SUBJECT: AMENDMENTS NOS. 127 AND 113 TO FACILITY OPERATING LICENSES NOS. DPR-58
AND DPR-74: (TACS NOS. 67786 AND 67787)

The Commission has issued the enclosed Amendment No. 127 to Facility Operating License No. DPR-58 and Amendment No. 113 to Facility Operating License No. DPR-74 for the Donald C. Cook Nuclear Plant, Units Nos. 1 and 2. The amendments consist of changes to the Technical Specifications in response to your application dated March 4, 1988.

These amendments provide enhancement to the "Instrumentation and Design Features" sections of the Technical Specifications for the meteorological monitoring system.

SAFETY EVALUATION BY THE OFFICE OF NUCLEAR REACTOR REGULATION
RELATED TO AMENDMENT NO.127 TO FACILITY OPERATING LICENSE NO. DPR-58
AND AMENDMENT NO.113 TO FACILITY OPERATING LICENSE NO. DPR-74

FIGURE 5.1-3: SITE BOUNDARY FOR LIQUID AND GASEOUS EFFLUENTS

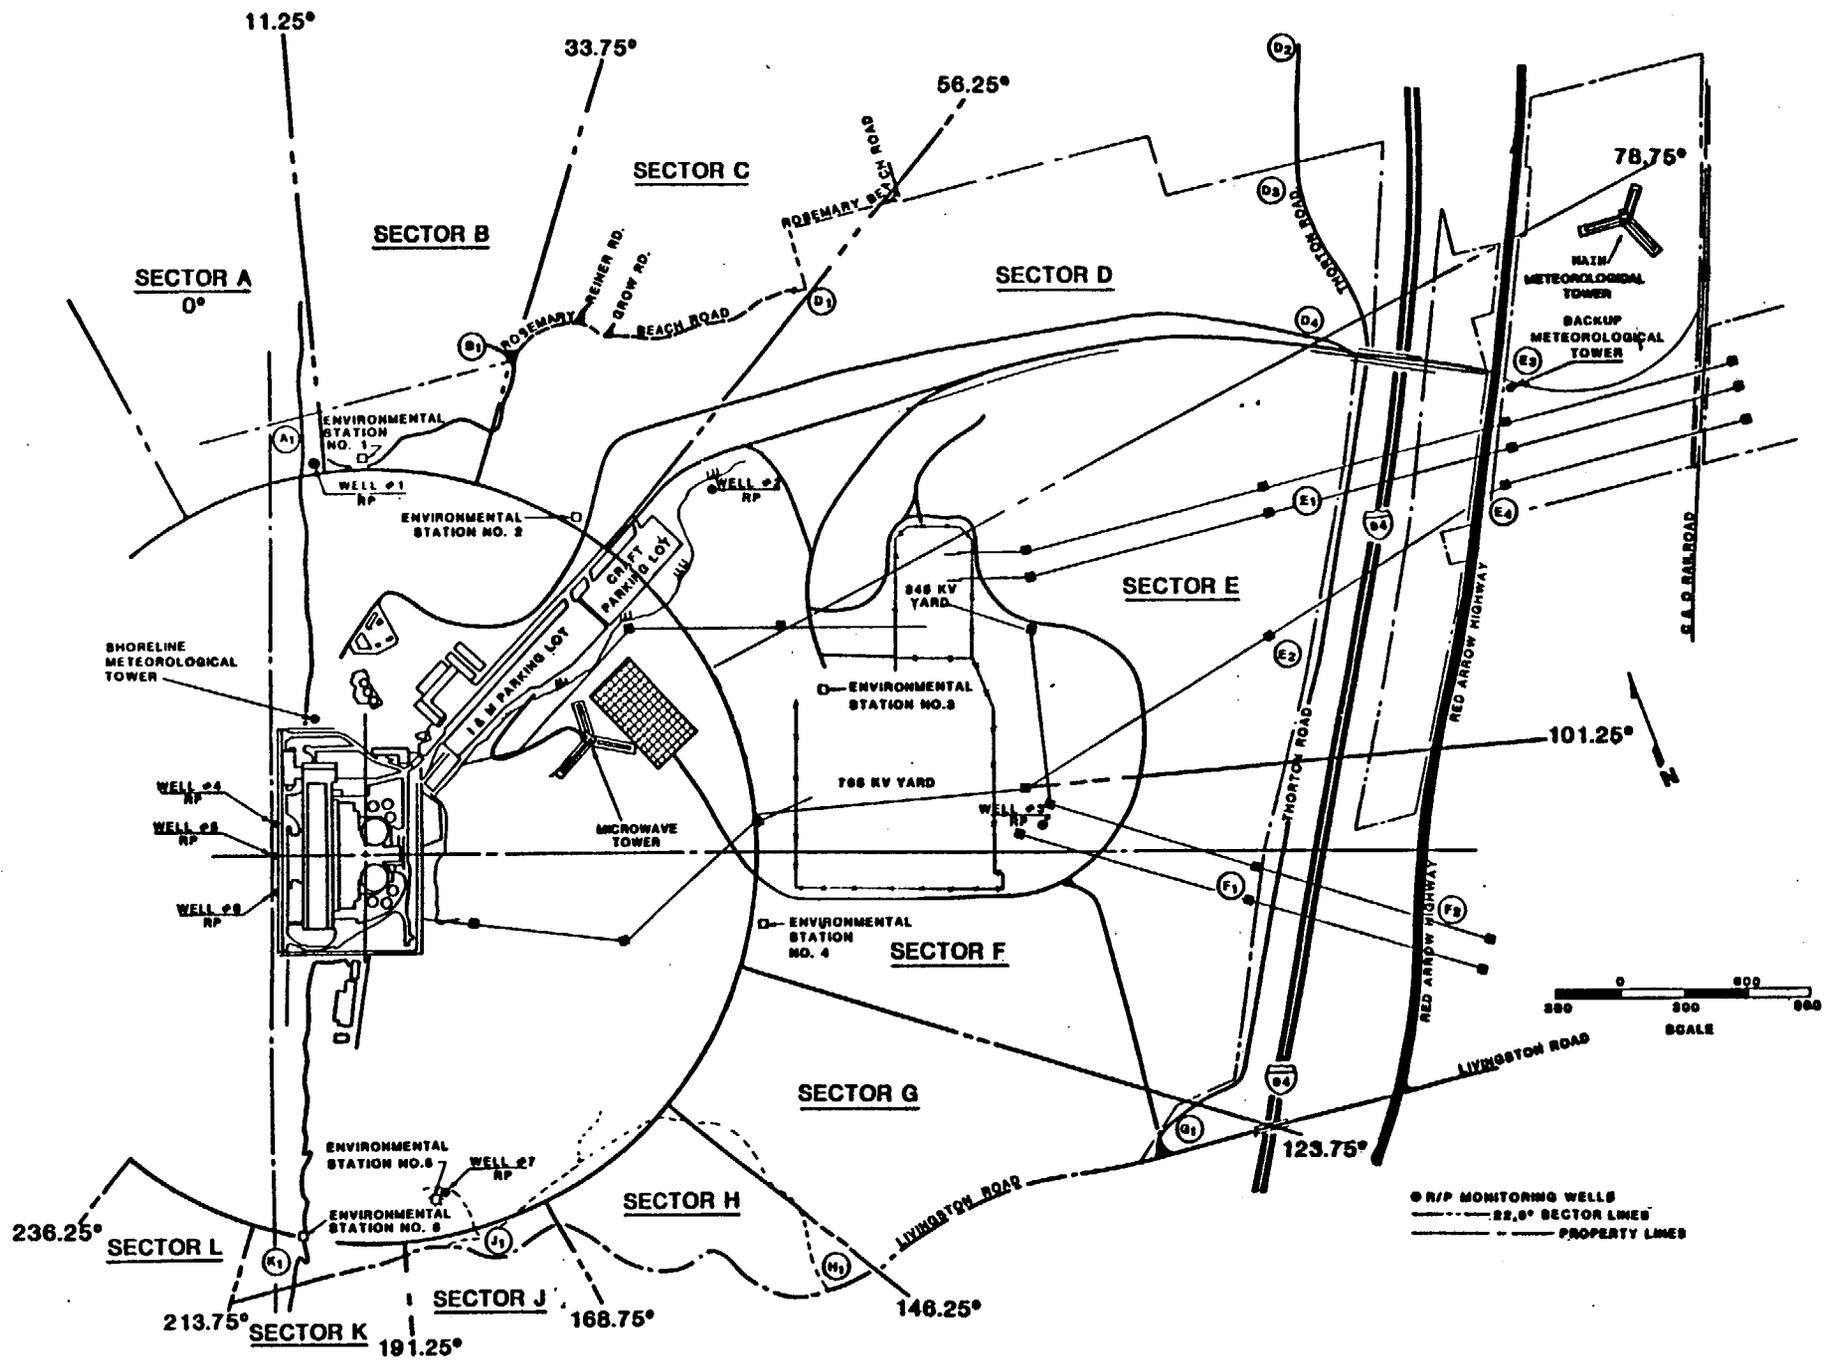
The new primary and backup meteorological towers are both located east of the plant facilities where the terrain is relatively flat, and a shoreline tower is located adjacent to the plant facilities and Lake Michigan. Wind speed and direction will be measured on all three towers. In addition, temperature and dew point will be measured on the primary and shoreline towers. Precipitation measurements will be made at the primary tower. The staff finds the location of the primary and backup towers suitable to provide data that is representative of the meteorological conditions in the Emergency Planning Zone. The shoreline tower will provide data representing conditions of the unmodified marine air near the plant facilities. The location of the new meteorological towers are included in the proposed TS changes in TS Figure 5.1-3.

The remaining proposed TS changes provide the elevation of the wind speed, wind direction and air temperature instrumentation installed on the primary and backup meteorological towers and the locations of the new towers. These proposed changes are intended solely to reflect the configuration of the as-installed meteorological monitoring system and are acceptable to the staff.
